## Florida Department of Transportation

### **STRUCTURES DESIGN BULLETIN 14-07**

SUBJECT: Attachments to Traffic Railings

**Figure 1.9-1 Special Details for Attaching Miscellaneous Items to Traffic Railings**

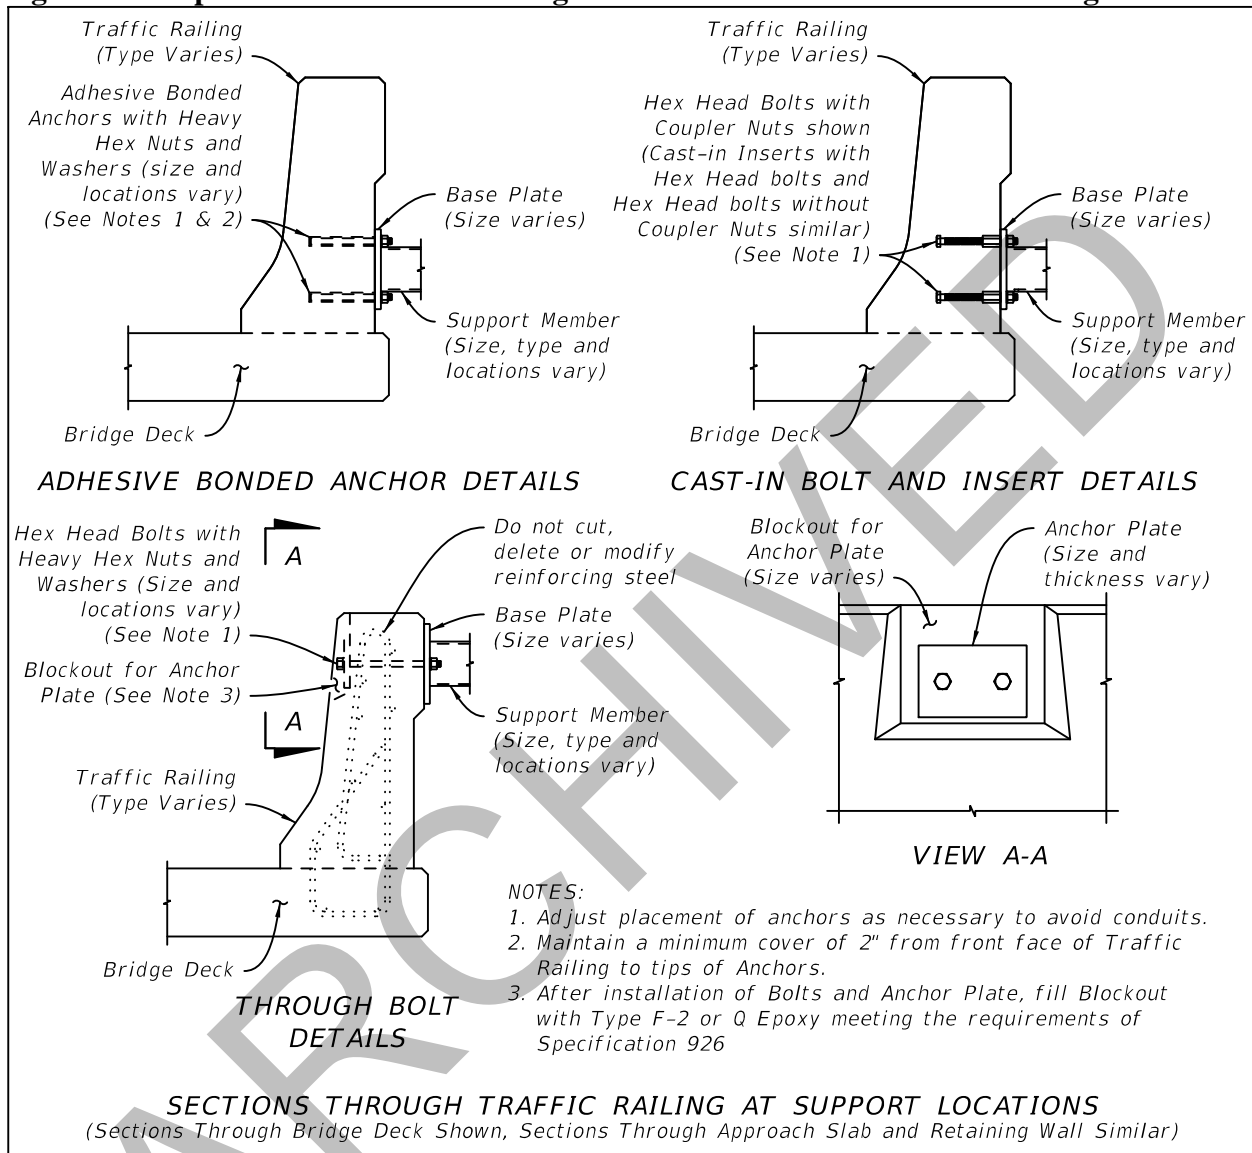
- D. Attach supports for sign structures and other similar miscellaneous items to the back face of New Jersey Shape, F-Shape, Vertical Face and structurally continuous Post and Beam outside shoulder traffic railings using the details shown in Figure 1.9-1. See also *PPM* Volume 1, Section 7.1.2 for additional requirements. Contact the Structures Design Office for guidance when attaching supports to all other traffic railing types. Do not attach supports to traffic railings within 5 feet of an open joint in the railing. Check the capacity of the traffic railing and the deck at the support location using the Strength III, Service I and Extreme Event II load combinations. Although intended for use with the outside shoulder traffic railing types listed, the details presented in Figure 1.9-1 can also be used for attaching items to concrete pedestrian railings.
